### ADDENDUM NO. 2 November 14, 2023

### Burnet City Hall – RFP 2023-012 PID: CIPSP-2022B

This Addendum forms a part of the Contract and clarifies, corrects or modifies the original Construction Documents, plans dated <u>9/15/2023</u>. Acknowledge receipt of this addendum in space provided on Proposal. Failure to do so may subject bidder to disqualification.

ROOF FRAMING PLAN

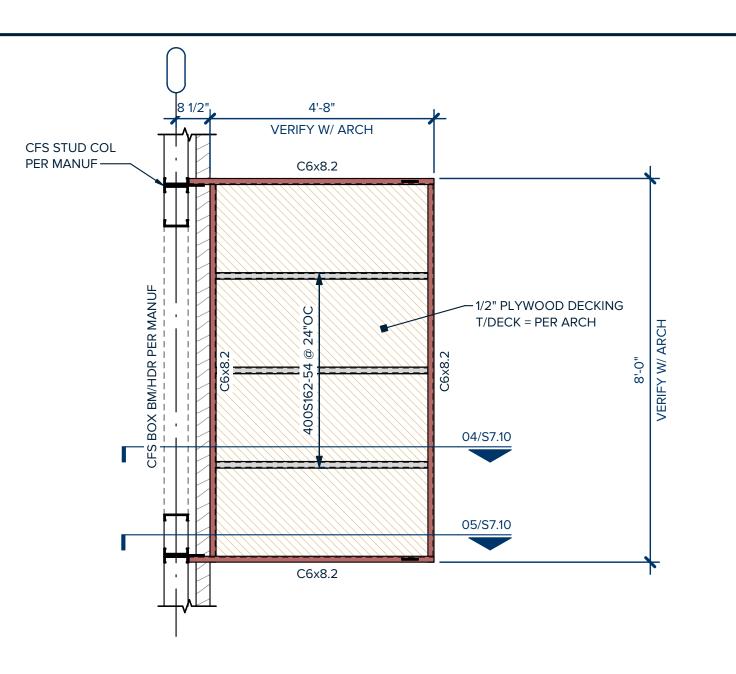
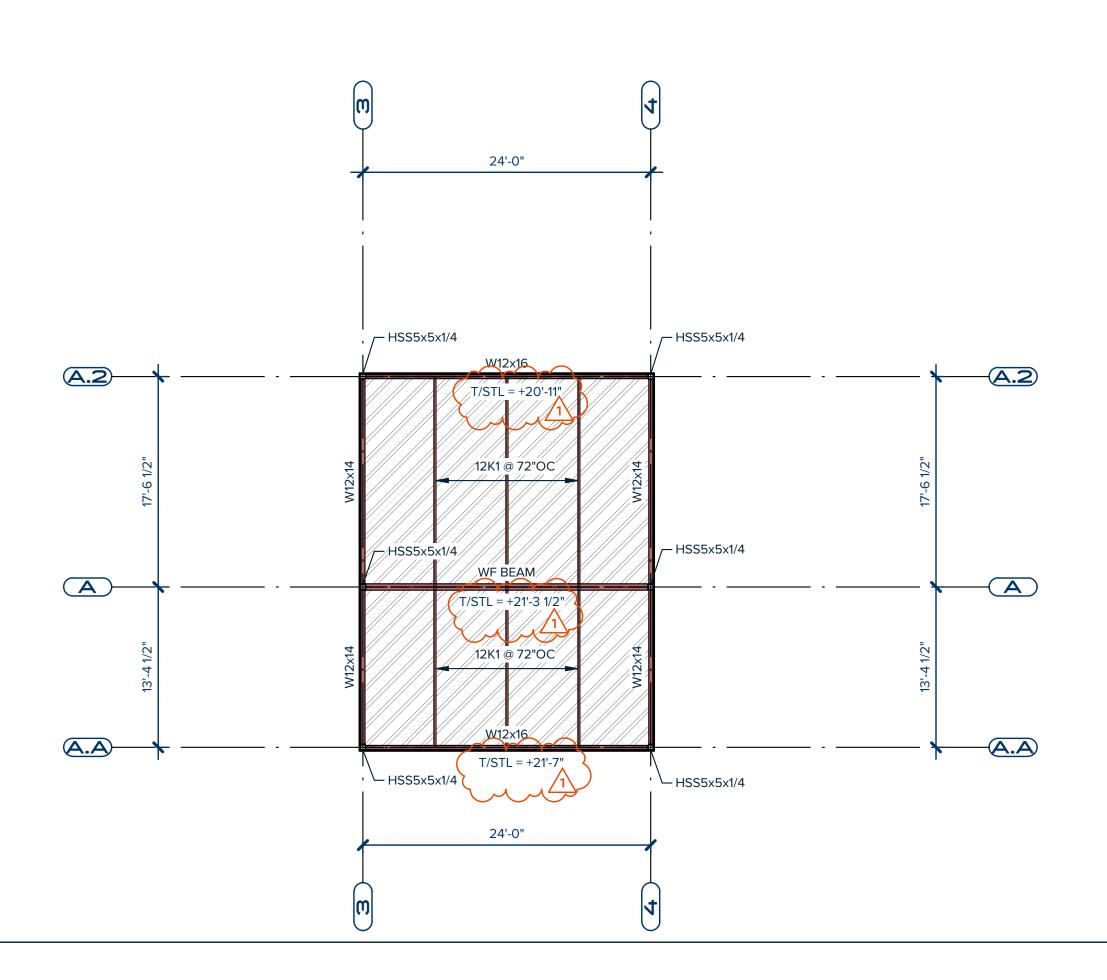
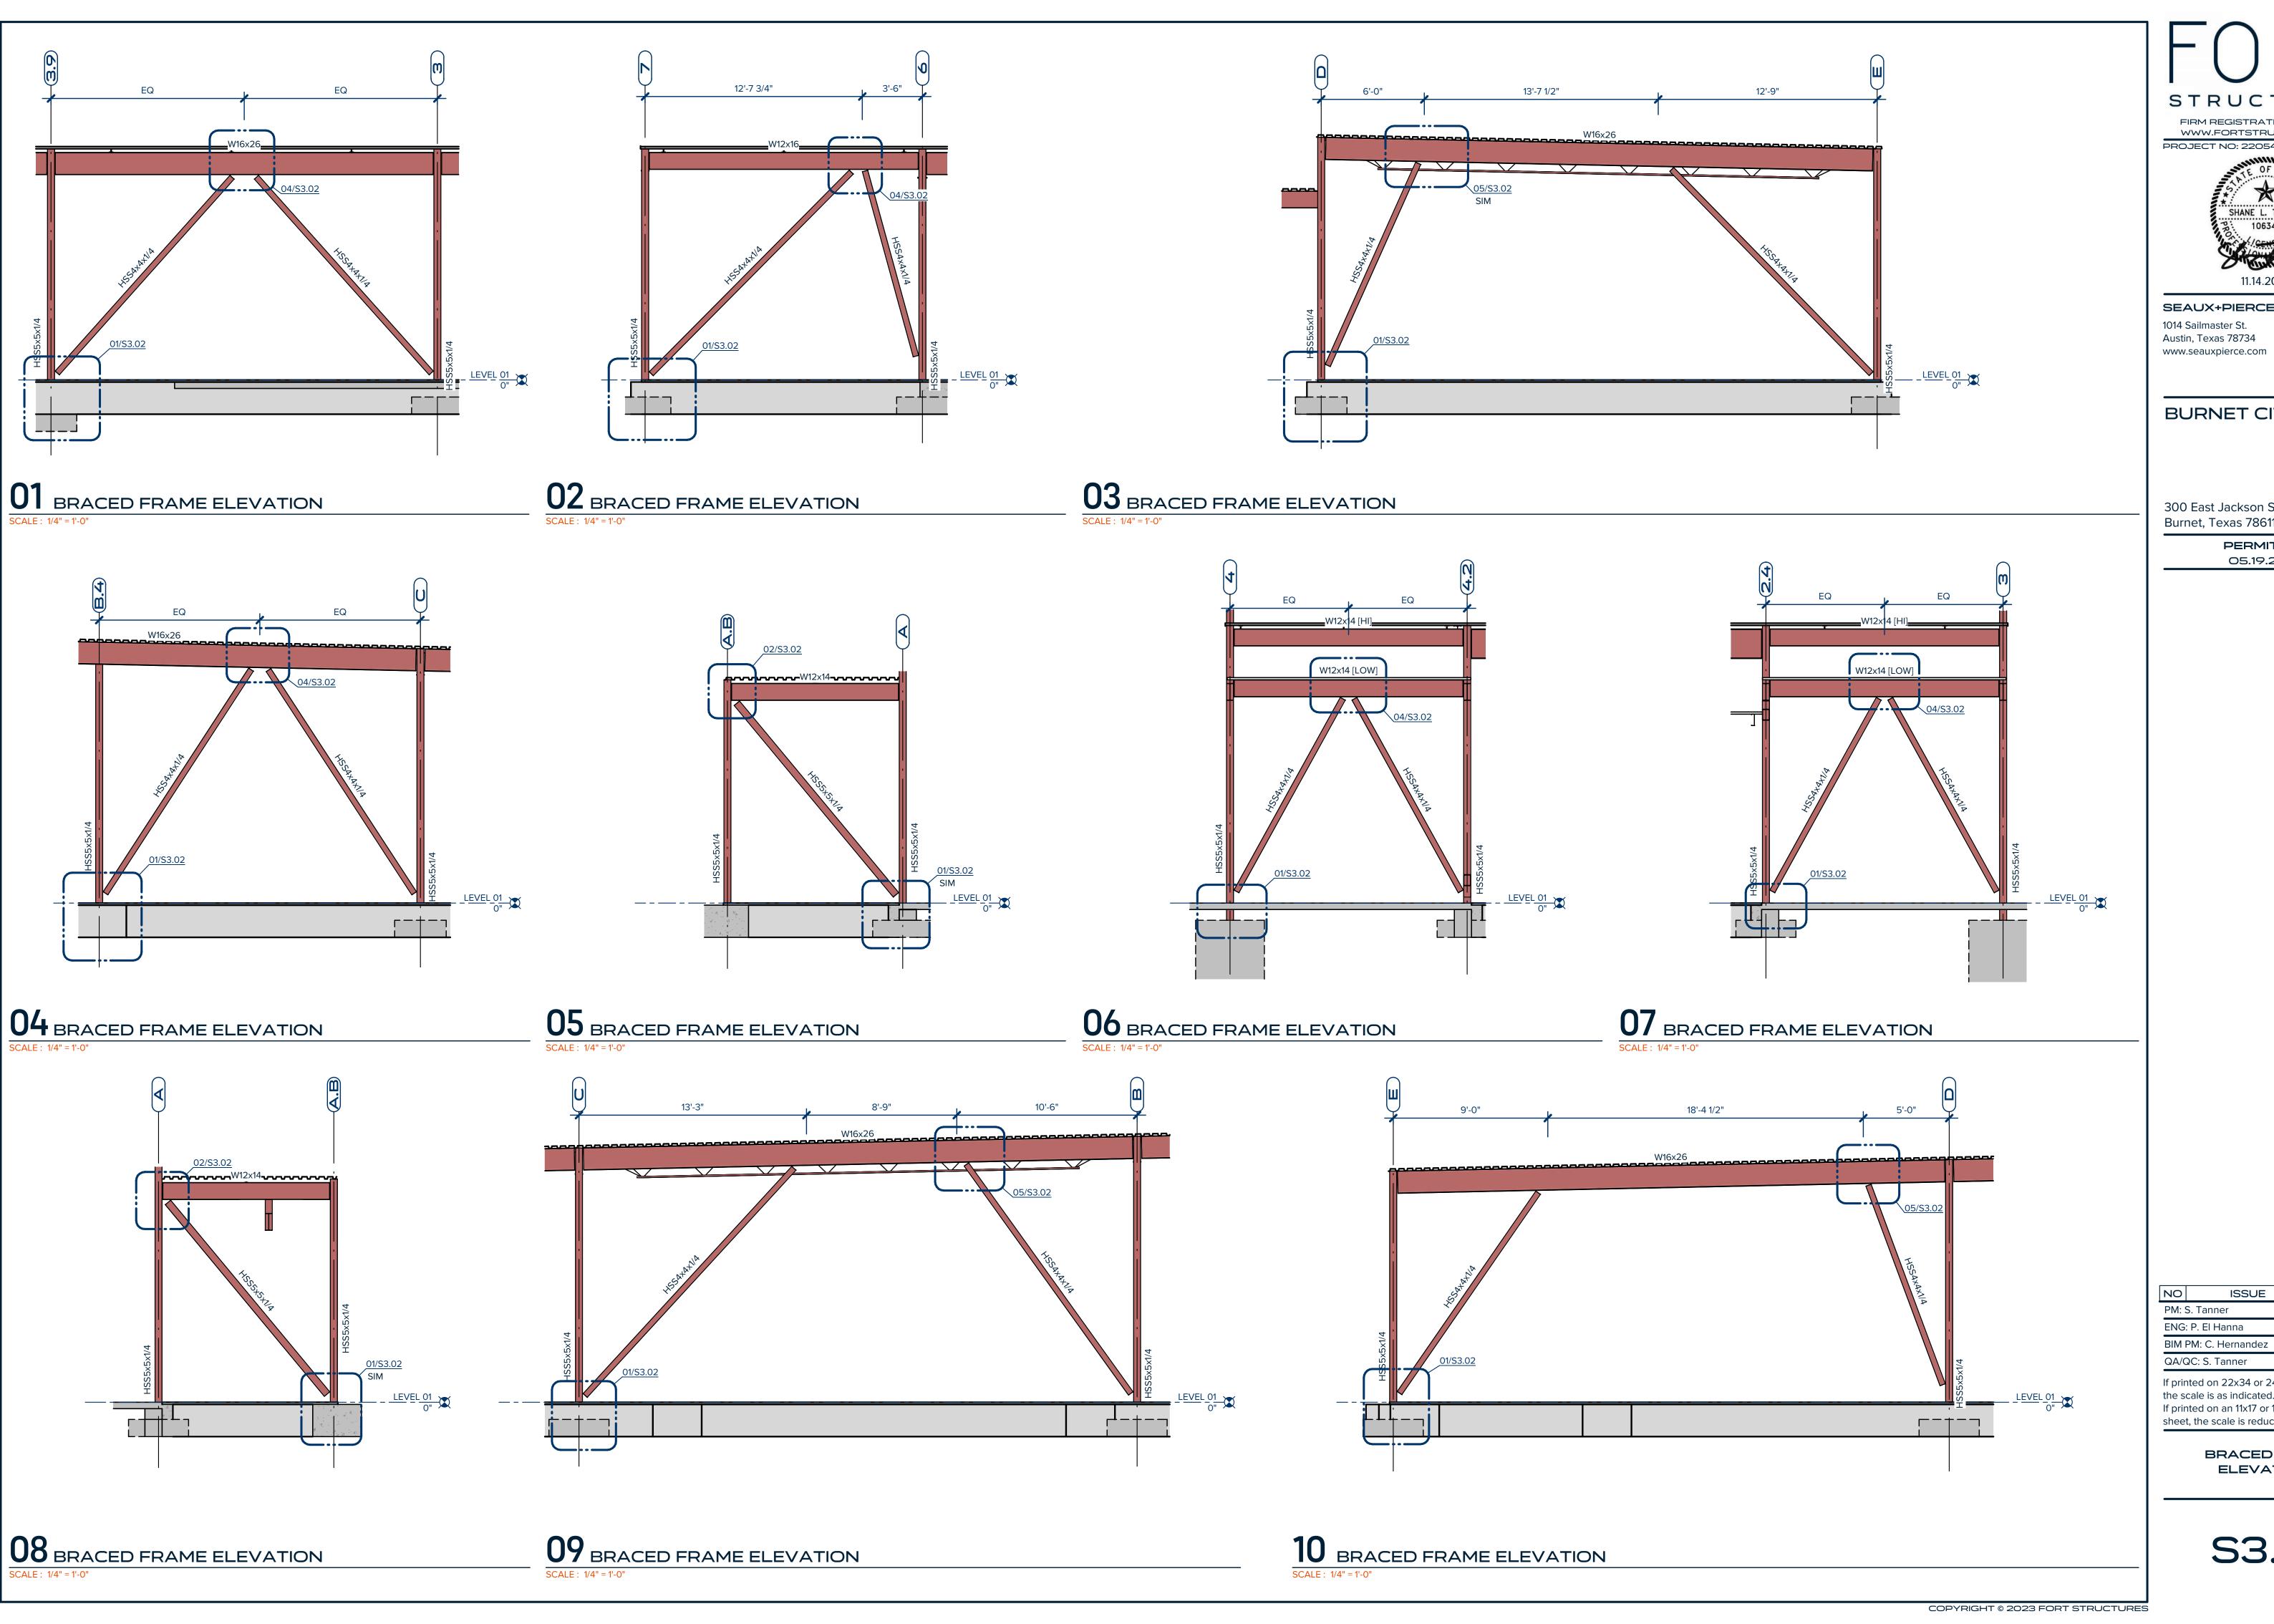
- 18. Sheet S2.01 (Foundation Plan)
  - a. Adjusted the brick lug from 5-1/2" to 7-1/2" to support stone wainscot.
  - b. Added dimension to pilasters.
- 19. Sheet S2.02 (Roof Framing Plan)
  - a. Adjusted Top of Steel to accommodate 1/4" roof slope.
  - b. Added missing steel lintels.
  - c. Added notes for roof framing at porch roofs.
- 20. Sheet S2.03 (High Roof Framing Plan)
  - a. Adjusted Top of Steel to accommodate 1/4" roof slope.
- 21. Sheet S3.01 (Braced Frame Elevations)
  - a. Adjusted to accommodate roof pitch.
- 22. Sheet S4.10 (Foundation Details)
  - a. Revised brick lug dimensions.
